Contract #: 04-0120F4
 Cty: SF/ALA Rte: 80 PM: 13.2/13.9
 File #: 69.25B

QUALITY ASSURANCE -- NON-CONFORMANCE REPORT

Location: Changxing Island, Shanghai, PRC **Report No:** NCR-000264
Prime Contractor: American Bridge/Fluor Enterprises, a JV **Date:** 08-May-2009
Submitting Contractor: Zhenhua Port Machinery Company, Ltd (ZPMC), Changxing Island **NCR #:** ZPMC-0238

Reference Description: Inconsistent Bevel and Excessive/Inconsistent Root Opening at Longitudinal Diaphragm-Bottom Panel-Side Panel Joint

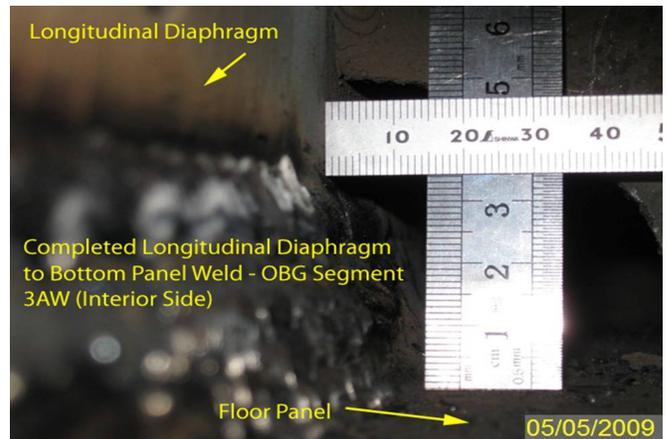
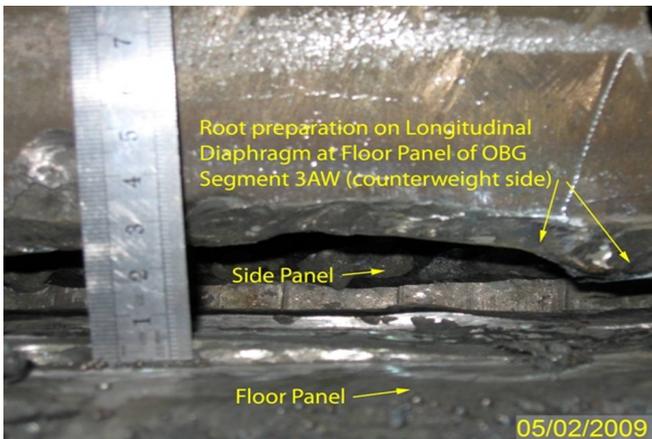
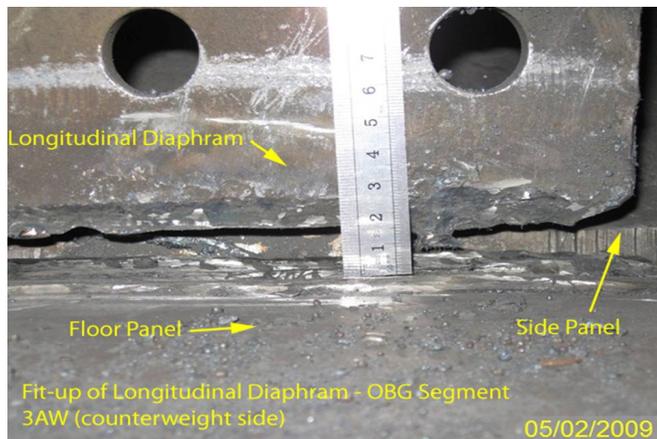
Caltrans Quality Assurance (QA) Inspector observed inconsistent bevel and excessive/inconsistent root opening at segment splice 3AW-3BW. This occurred where the segments were unzipped and adjusted for proper segment alignment at the longitudinal diaphragm - bottom panel - side panel joints. The panels affected are:

- BP101A, SP025A, LD017-003(Working Point W3, Segment 3AW)
- BP103A, SP070B, LD018-003(Working Point W4, Segment 3AW)

3.2.1 "Surfaces and edges to be welded shall be smooth, uniform, and free from fins, tears, cracks, and other discontinuities which would adversely affect the quality or strength of the weld."

3.2.3 "Steel and weld metal may be thermally cut, provided a smooth and regular surface free from cracks and notches is secured, and provided that an accurate profile is secured by the use of a mechanical guide."

Reference Resolution: ZPMC have finished welded this weld joint. This weld joint is a CJP, therefore weld will be subsequently backgouged and inspected.

ZPMC have finished welded this weld joint. This weld joint is a CJP, therefore weld will be subsequently backgouged and inspected. ZPMC to submit the welding repair report as well as all related inspection documentation at a later date.

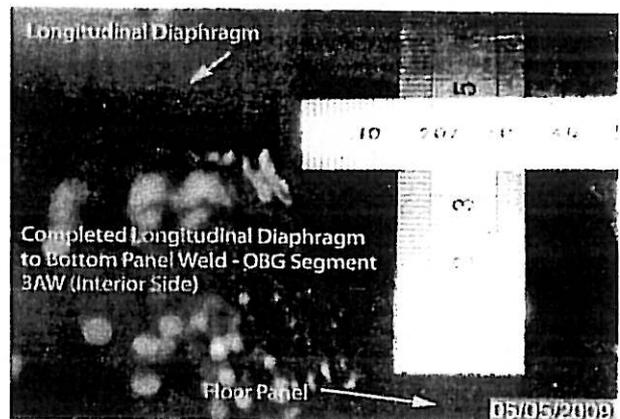
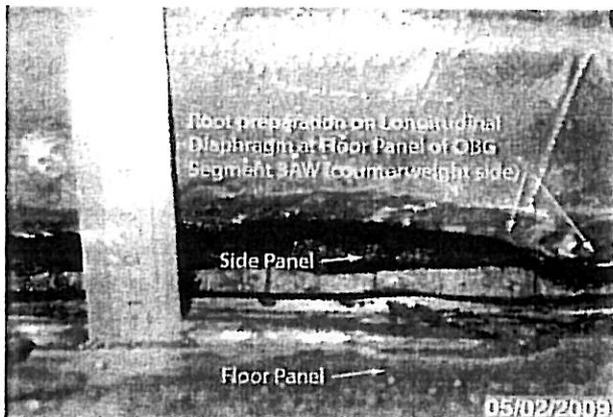
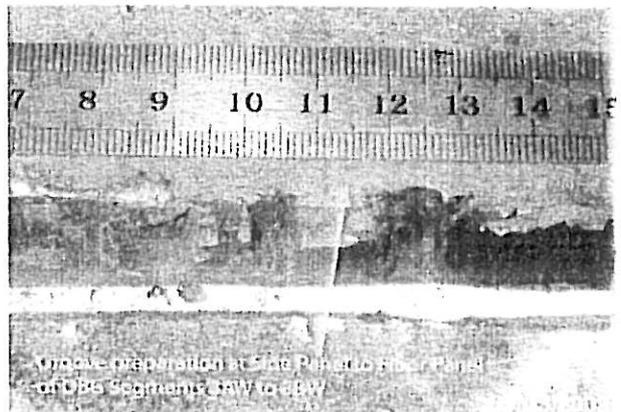
Caltrans Quality Assurance (QA) Inspector observed inconsistent bevel and excessive/inconsistent root opening at segment splice 3AW-3BW. This occurred where the segments were unzipped and adjusted for proper segment alignment at the longitudinal diaphragm - bottom panel - side panel joints. The panels affected are:

-BP101A, SP025A, LD017-003(Working Point W3, Segment 3AW)

-BP103A, SP070B, LD018-003(Working Point W4, Segment 3AW)

3.2.1 "Surfaces and edges to be welded shall be smooth, uniform, and free from fins, tears, cracks, and other discontinuities which would adversely affect the quality or strength of the weld."

3.2.3 "Steel and weld metal may be thermally cut, provided a smooth and regular surface free from cracks and notches is secured, and provided that an accurate profile is secured by the use of a mechanical guide."

Draft of welding discontinuity:

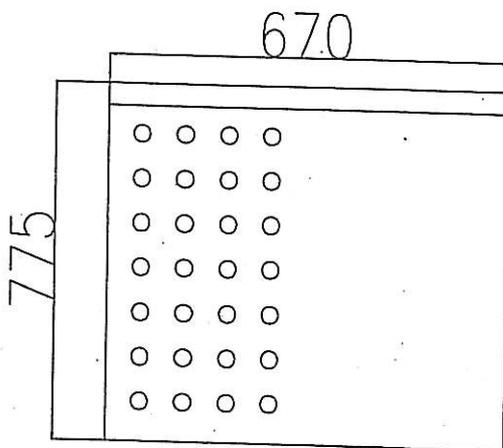
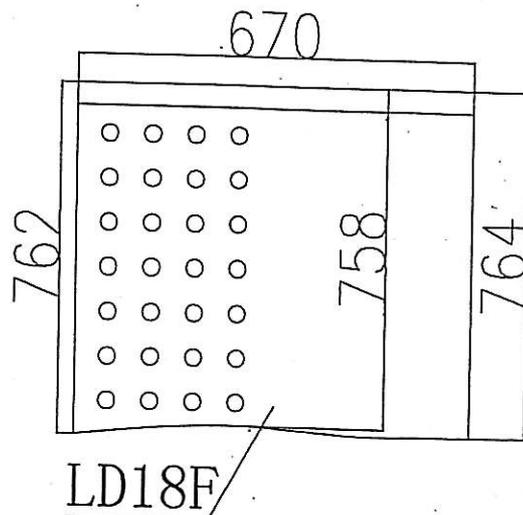
After inspection 3AE inner longitudinal LD18F, the size was shorter than drawing requirement, see the following draft.

The worker operated error caused base metal gouged.

1. Prepare excavation with relevant WPS.
2. VT to verify repair area is free of all defects.
3. Add steel backing at the back of groove according to AWS D1.5.3.13;
4. Preheat and weld according to the relevant WPS.
5. Gouge off the steel backing and grind the weld flush with base metal after welding;
6. Perform NDT inspection of the weld according to the working drawings.
